## Invitation to Bid: Construction Fire Station 49 Addendum 4 October 31, 2025

### **NCFRC Station #49 Precon RFI**

**Response #5**

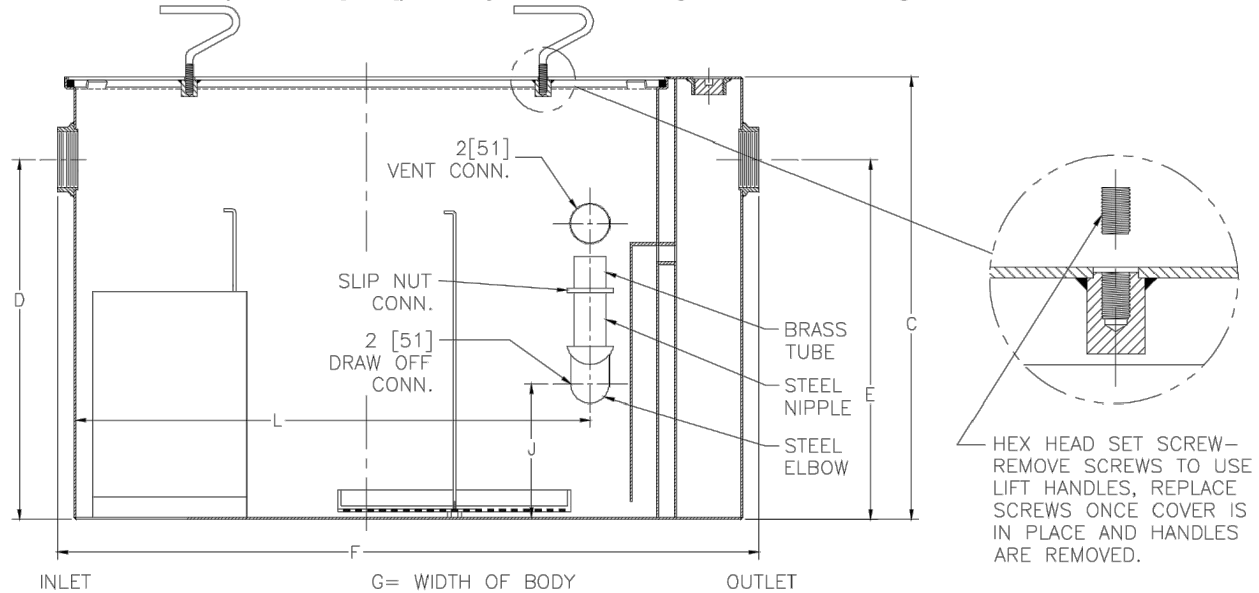
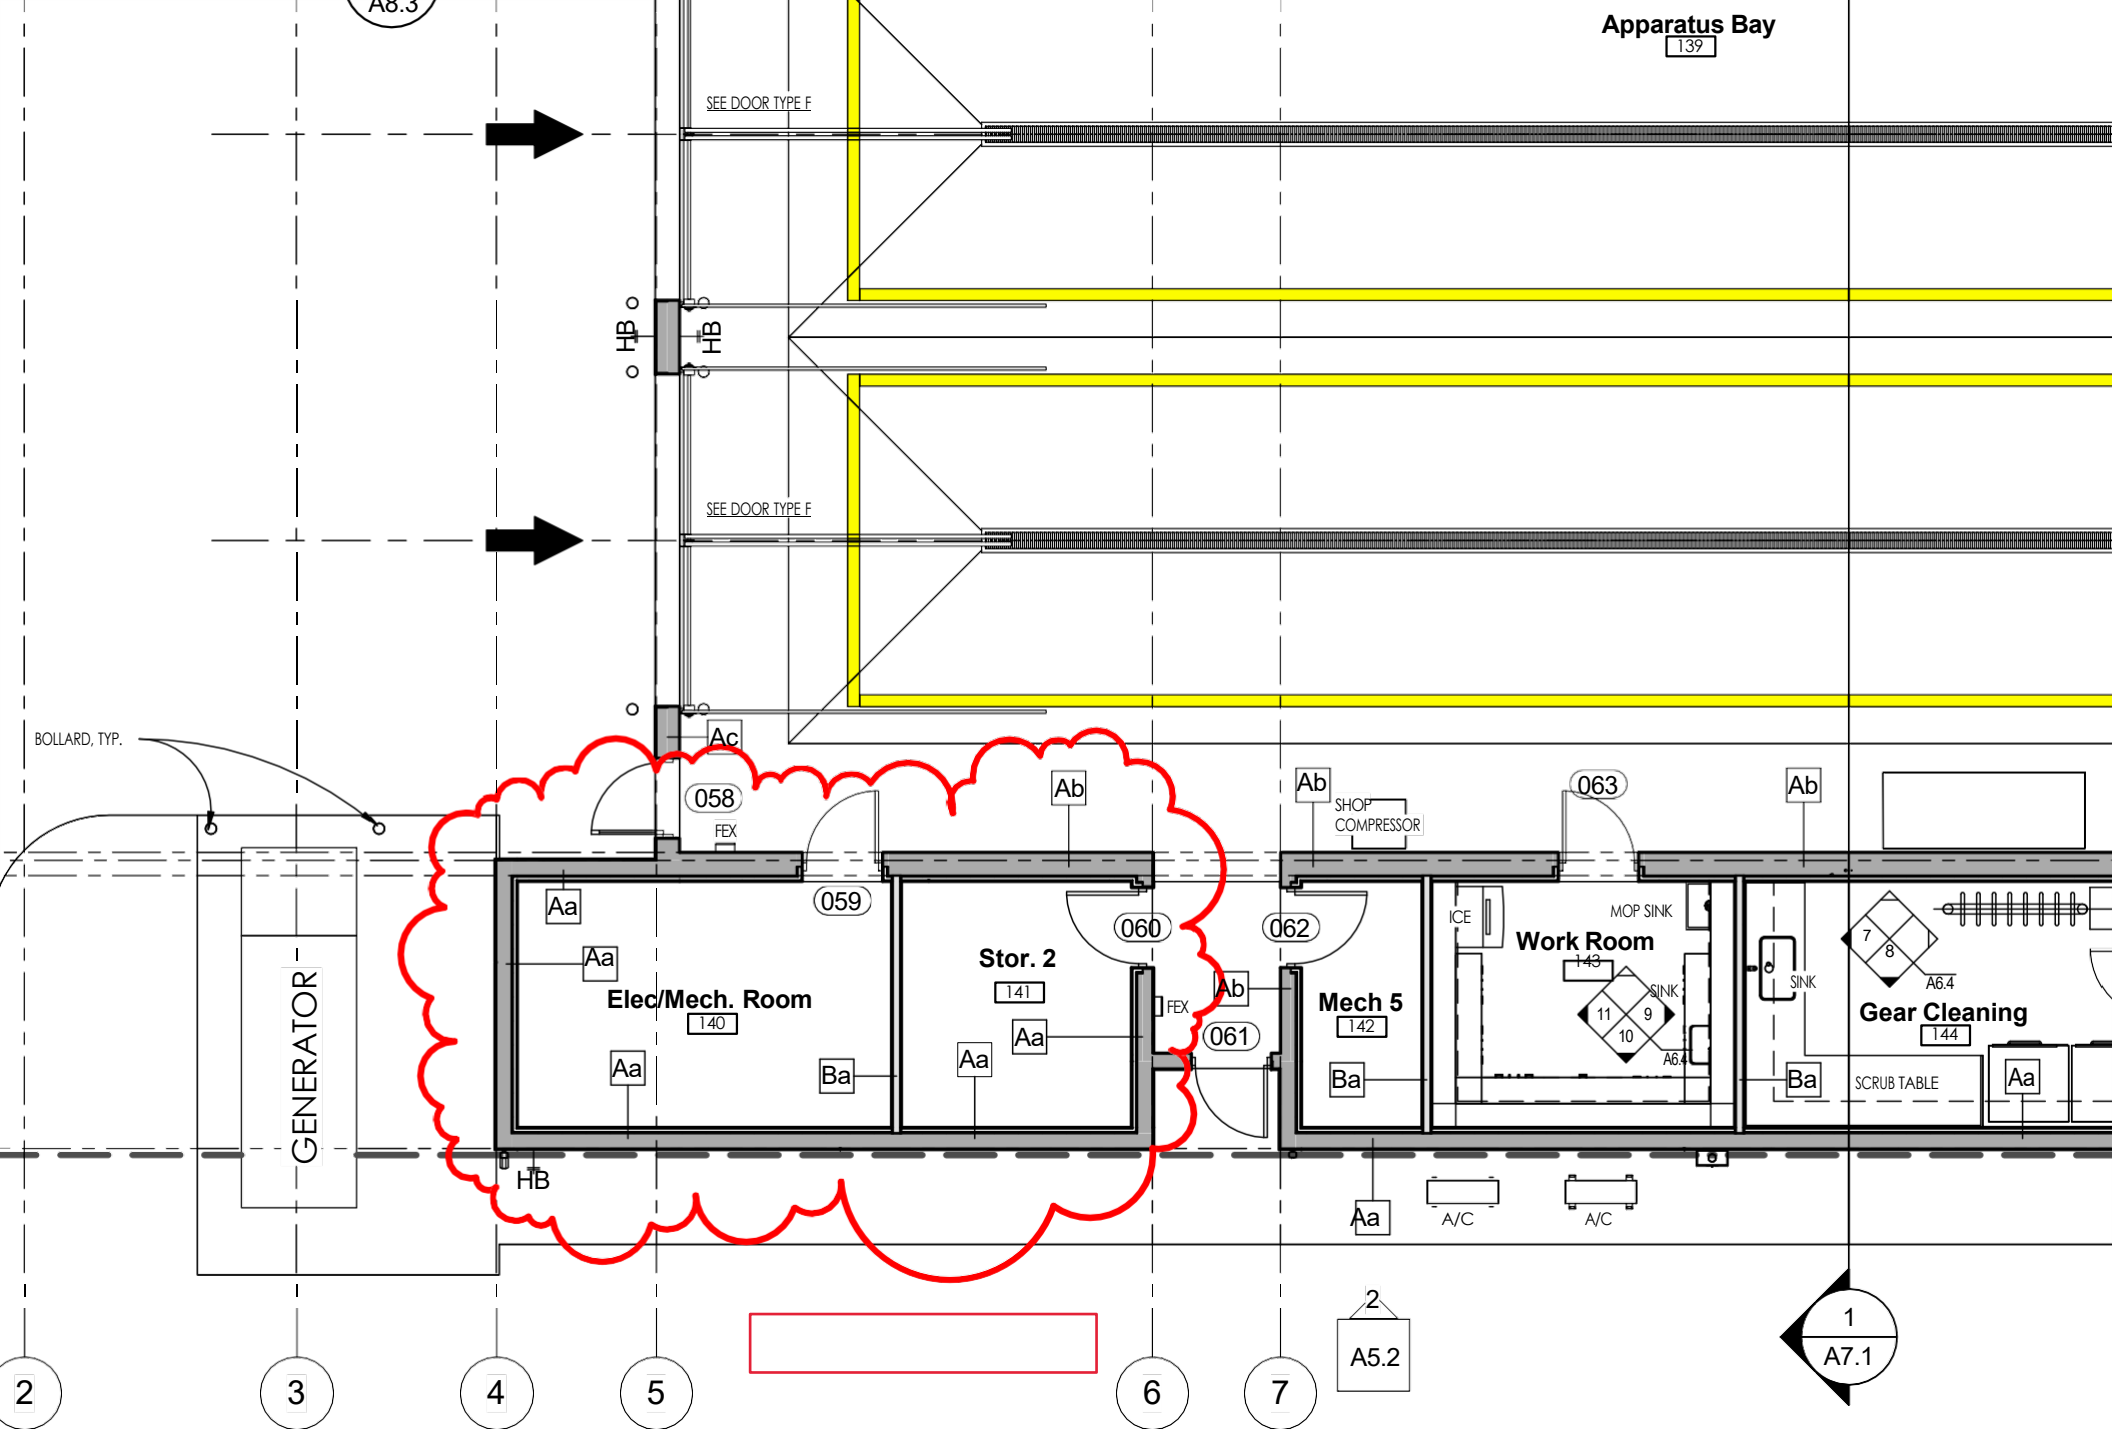
**Note #2 shall be removed from the plans and the 3 lights that are tagged shall be wired to the adjacent circuit.**
5. Please see Plumbing drawing P0.3 . We have been told by supplier that the Oil interceptor is now discontinued, please provide spec for alternate OI oil interceptor.

**Zurn Model #Z1188. See attachment.**
6. Work room #143, on finish schedule it indicates FRP, on the elevation section sheet A6.4 it illustrates tile. Should we assume FRP.

Door Schedule

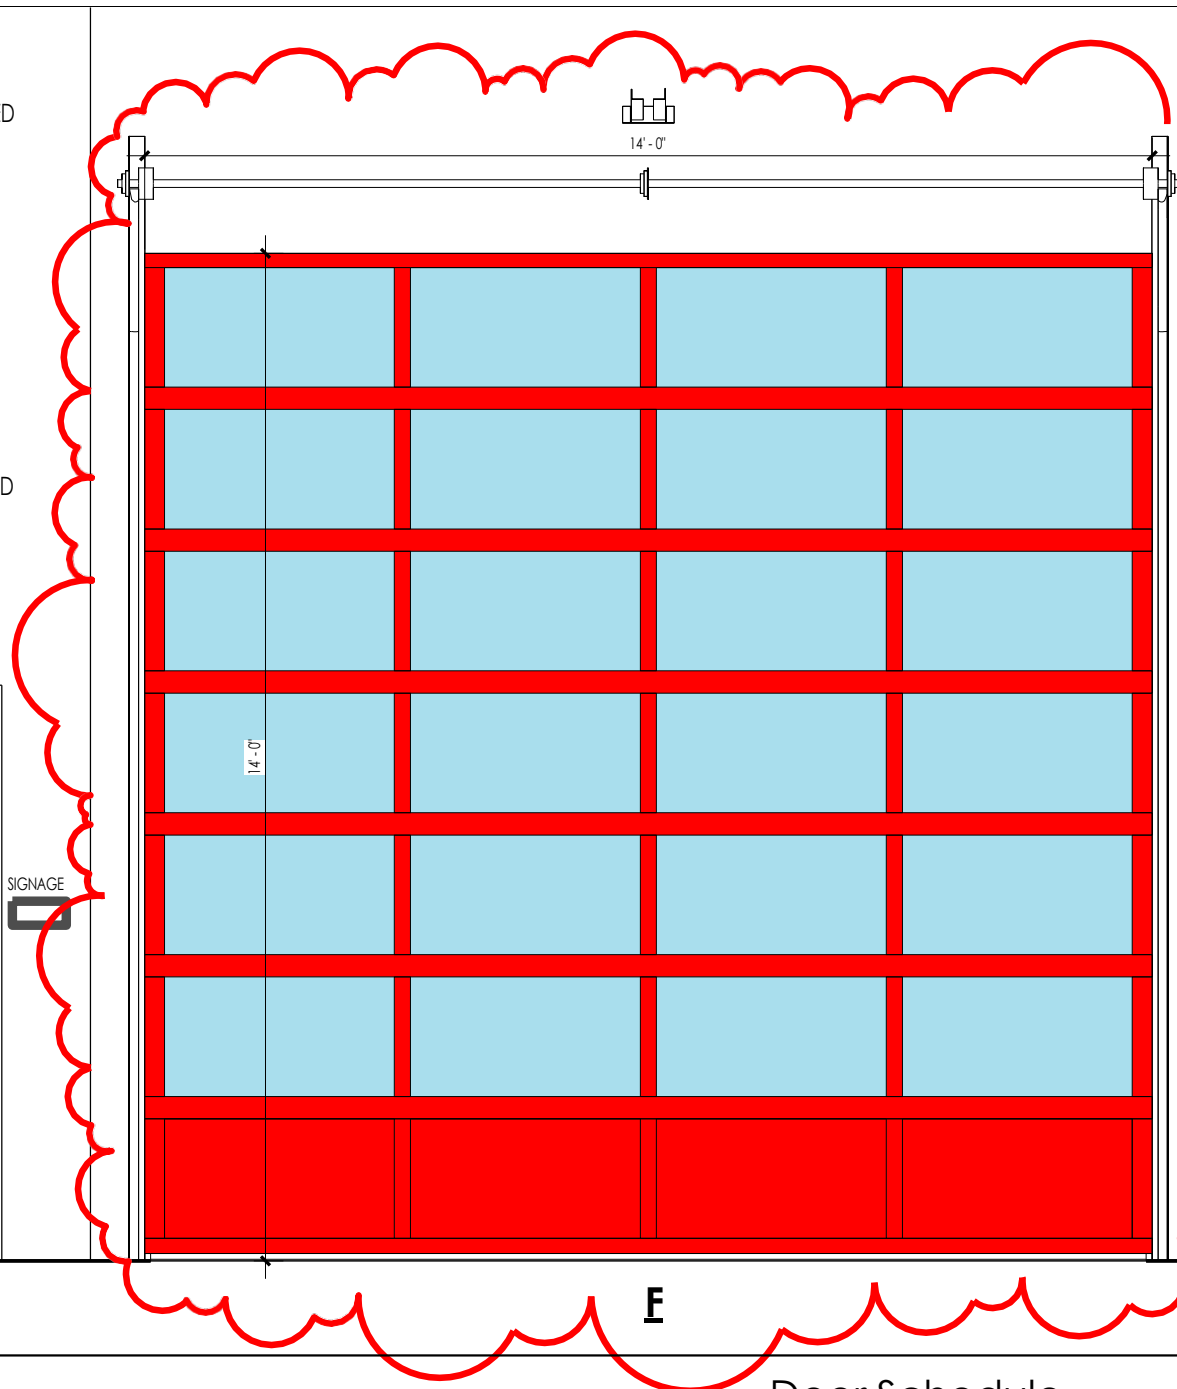
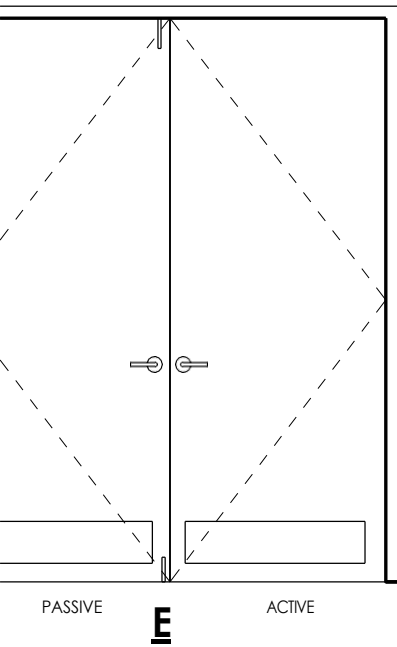
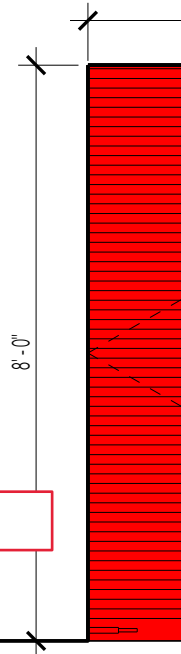
16. Please provide the sizes, quantities, for door TYPE F. Width x height x track design? High/Lift Track?

17. Please provide locations for OH Door Type G and confirm whether it is a counter door or rolling door.

**14'-0" x 14'-0" missing dimension have been added. See attachment. Track design is listed on sheet A6.1.**

**There are 4 type G doors in the Kitchen. Door 70 was missing from the schedule and has been readded. It Model 652 is a counter style door. See attachment.**
